PO TELECOMMS HQRS PAPER:- W DISTN:- GENERAL	ISSUE	D	Sheet 5 and Notes 10 and 11 added Relay NSA added to Fig 2. Notes 5, 8 and 9 amended. I.F.J. <i>JMK</i> ME/PD1.2.2	8.1.81
		C	FIG. 2 ADDED. NOTES RE-WRITTEN TO INCLUDE LOOP RINGING FACILITIES <i>JAR</i>	24.10.75
		B	GUARDED BATTERY SYMBOL CHANGED TO -05 TD7.2.1	8.10.68

H.E.S. No.4
RELAY-UNIT Q561, FIG.1 (NOTE 1)
FOR WIRING COLOURS USED IN UNIT SEE DGM. LD192

H.E.S. No.4
RELAY-UNIT Q516, FIG2 (MODIFIED TO BE SUITABLE FOR LOOP RINGING, SEE NOTES 4 & 10)
FOR WIRING COLOURS USED IN UNIT SEE DGM.LD192

RELAY UNIT Q516 HES No.4
FIG.3 EARTH RECALL (DELAY CIRCUIT SEE NOTE II)

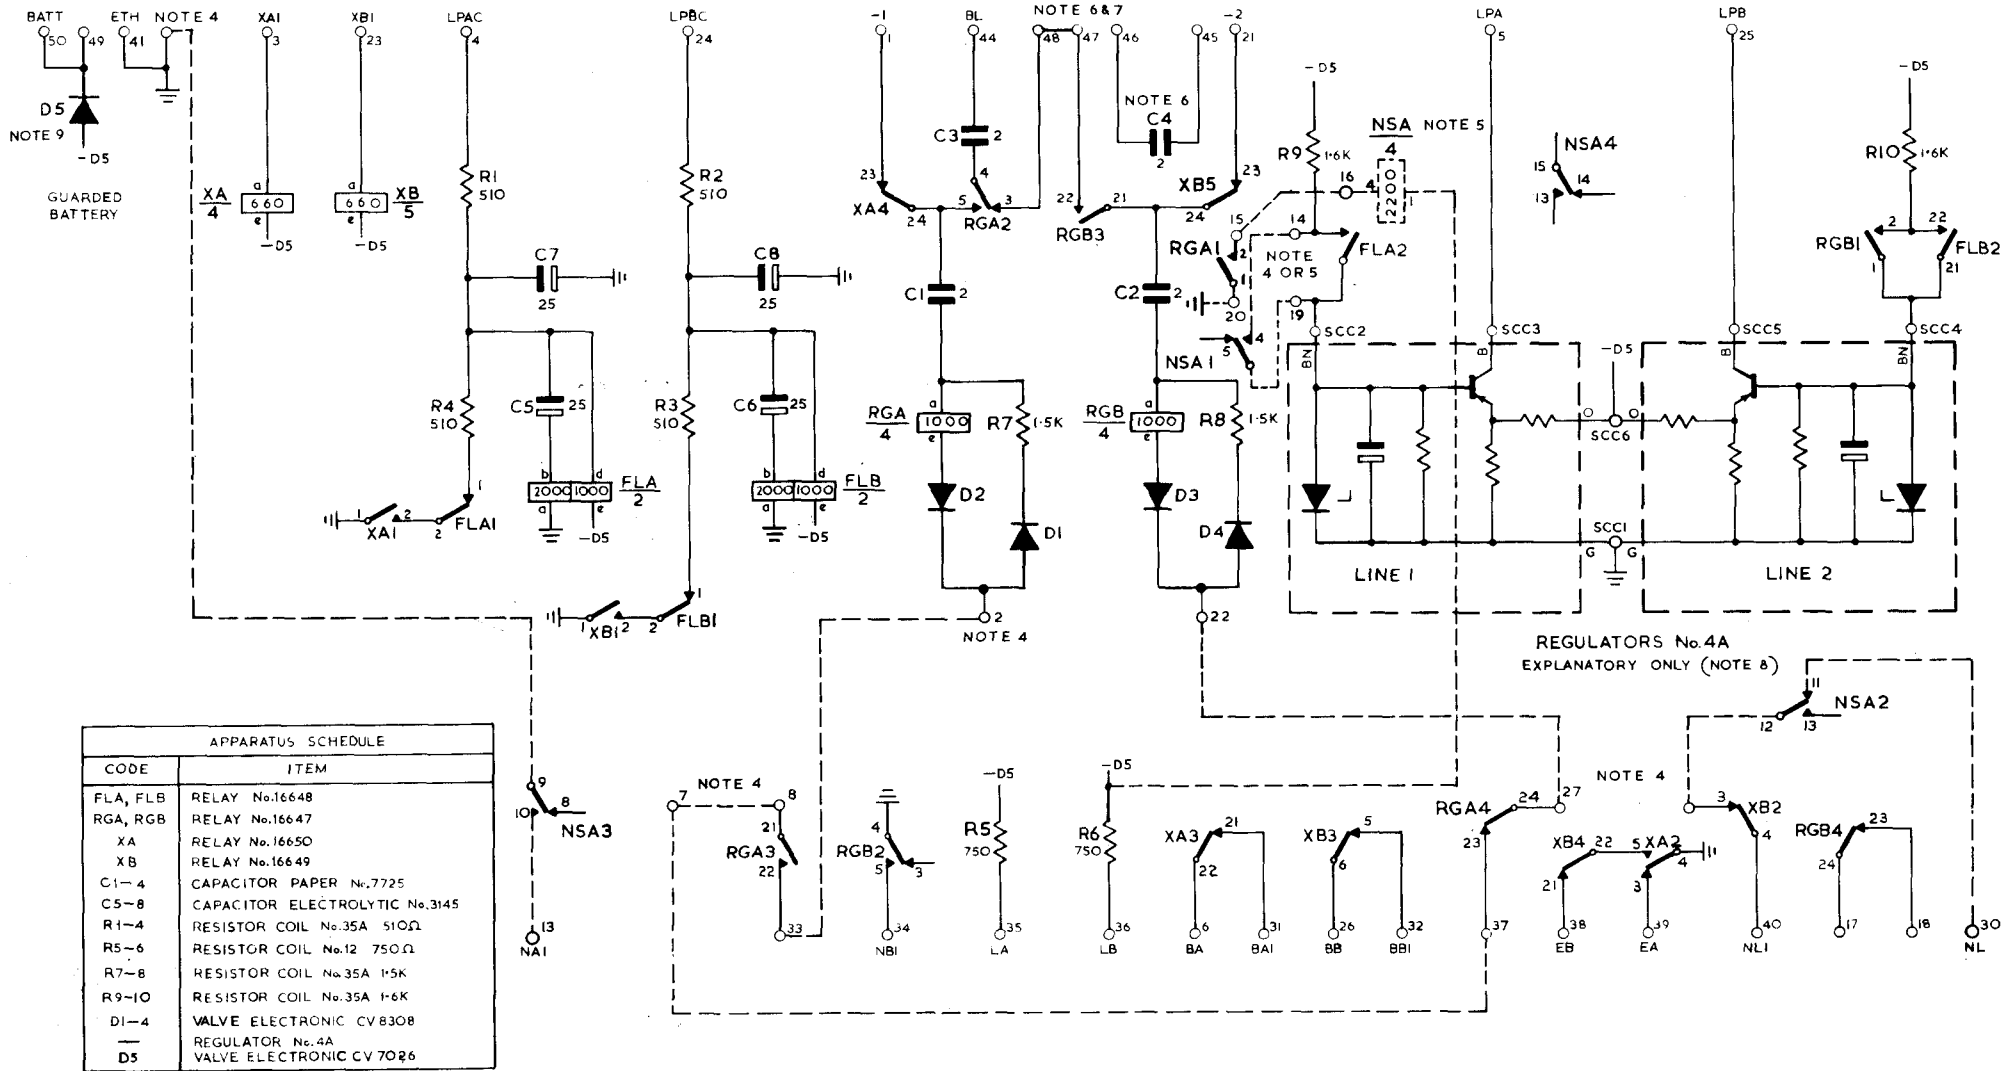
3. To modify a Relay-Unit Q 516 wired to Fig. 1 to conform to Fig 2 for Loop Ringing requires the following changes to the permanent wiring of the unit. See Label Diagram LD 192 for wiring colours.

- (a) Recover RED-GREEN wire connected between Relay RGA, spring 24 - Relay XB spring 3
 Recover BROWN wire connected between Relay RGA, spring 1 - Relay FLA spring 21
 Recover RED-SLATE wire connected between Relay RGA, spring 2 - Relay FLA spring 22
 Recover RED wire connected between Tag SCA 13 - Tag SCB 9 (Component Mounting)
 Remove 2 RED wires connected to Relay RGA, spring 21 solder wires together and insulate joint
 Shift BROWN wire from Relay RGA spring 1 to Relay FLA spring 21
 Shift RED-SLATE wire from Relay RGA spring 2 to Relay FLA spring 22
 Shift RED wire from Tag SCA 7 to Tag SCB 9 (Component Mounting)

Remove strap between Tags SCA 9 and SCA 11 (Component Mounting)

(b) Provide new wiring to terminals on Strip Connexion No. 212/1A as follows:-

- Relay FLA spring 21 - Terminal 19
- Relay FLA spring 22 - Terminal 14
- Relay RGA spring 1 - Terminal 20
- Relay RGA spring 2 - Terminal 15
- Relay RGA spring 21 - Terminal 8
- Relay RGA spring 24 - Terminal 27
- Relay XB spring 3 - Terminal 28
- Tag SCA 7 - Terminal 2
- Tag SCA 11 - Terminal 22

(c) Amend the Label Diagram, Dgm. LD 192, in the Relay-Unit Cover to conform to Dgm. Q 516 Fig. 2.
